Technical Bulletin

Subject: Spoiler Drive Cable Cap

Number
9103

Models Affected: *911 Carrera 2 and 911 Carrera 4
Model Year 89 (K) and 90 (L)*

Figure 1

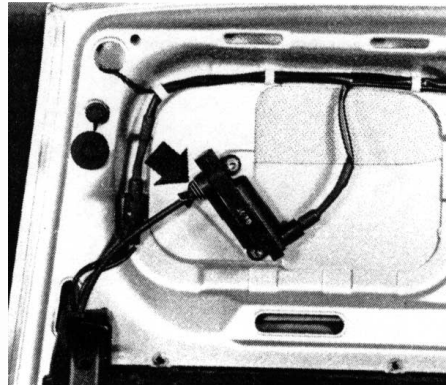
Concern: Water enters rear spoiler motor through spoiler drive cable cap (Figure 1).

Vehicle Information: A modified cap (different material) is installed from production date: June 5, 1990.

The cap should be replaced on all 89 (K) and 90 (L) model year vehicles up to the above VIN when the vehicle is in the workshop for normal service or other repairs.
